**DEPARTMENT OF TRANSPORTATION
STATE OF GEORGIA**

SUBJECT APPROVED PROJECT CONCEPT REPORT

10th Street Corridor Improvements

10th Street Corridor Improvements

TYPICAL SECTION (LIMITED ROW)

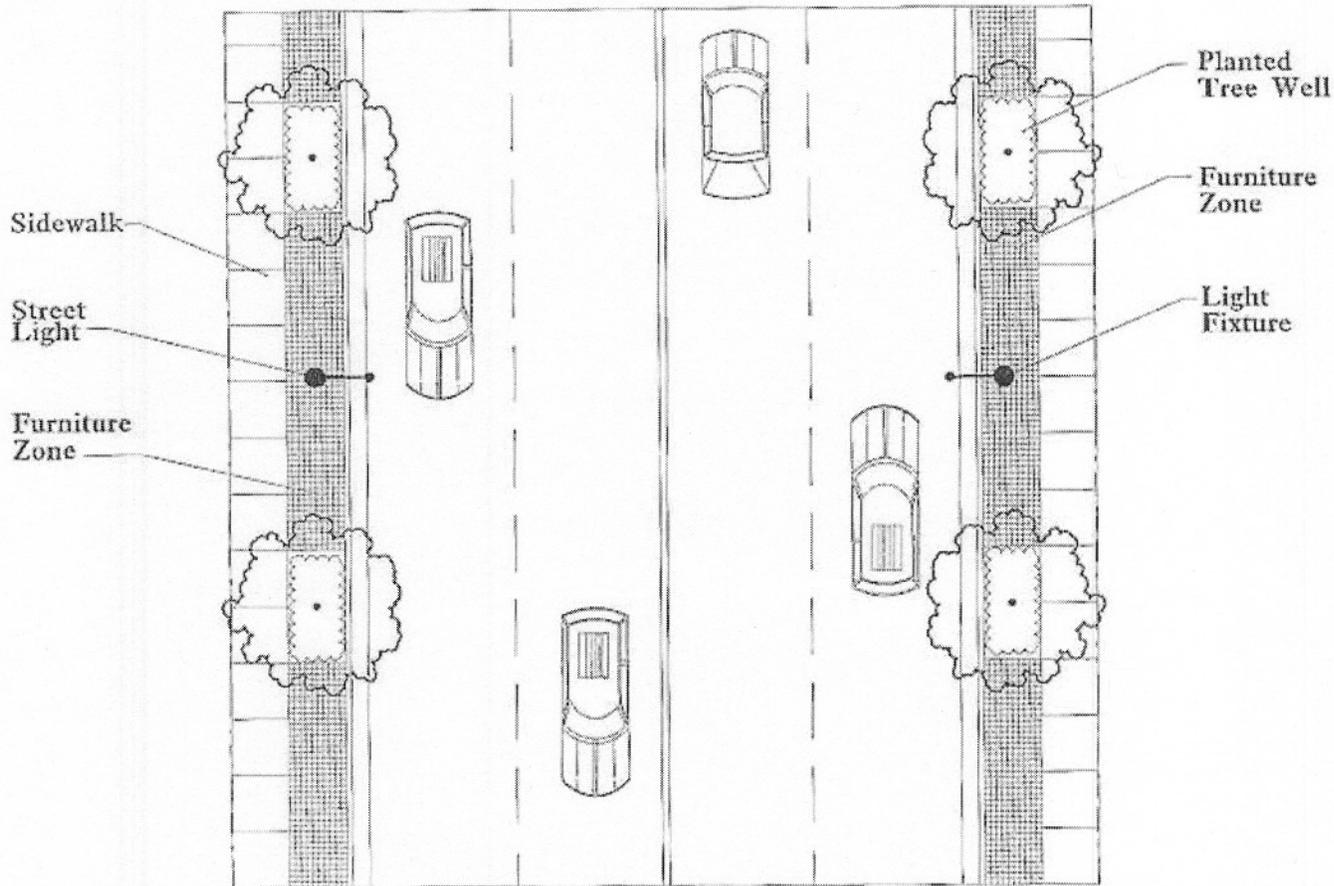
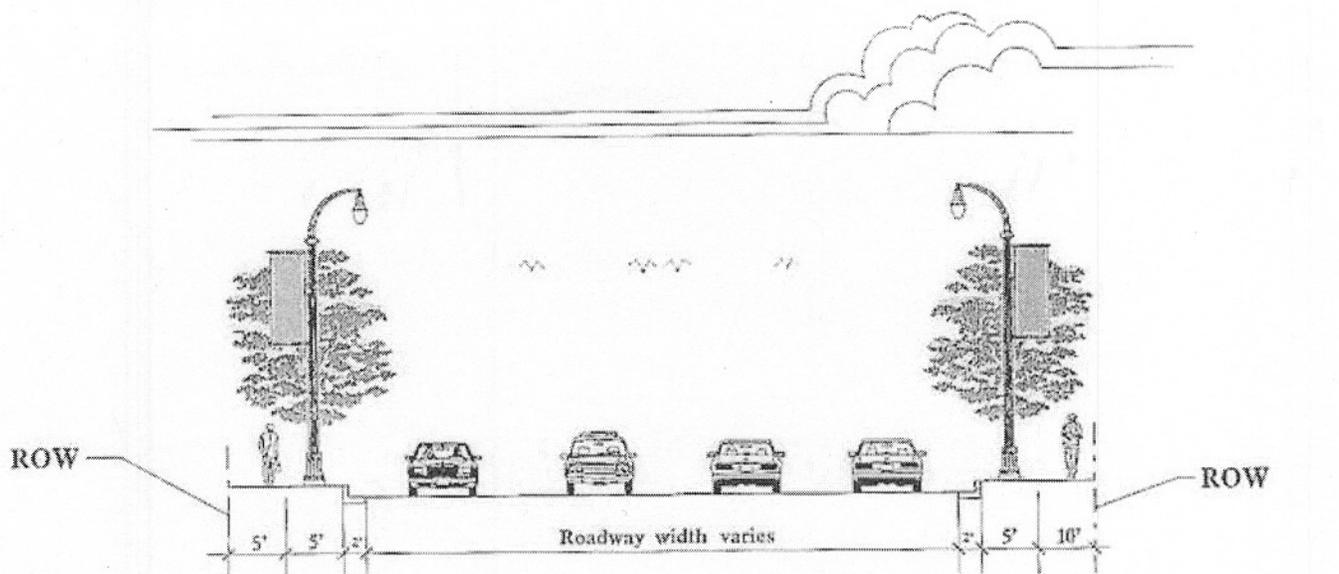
Note: Distance from Face of curb to tree should be increased from 3' to 4' as per revised streetscape guide.
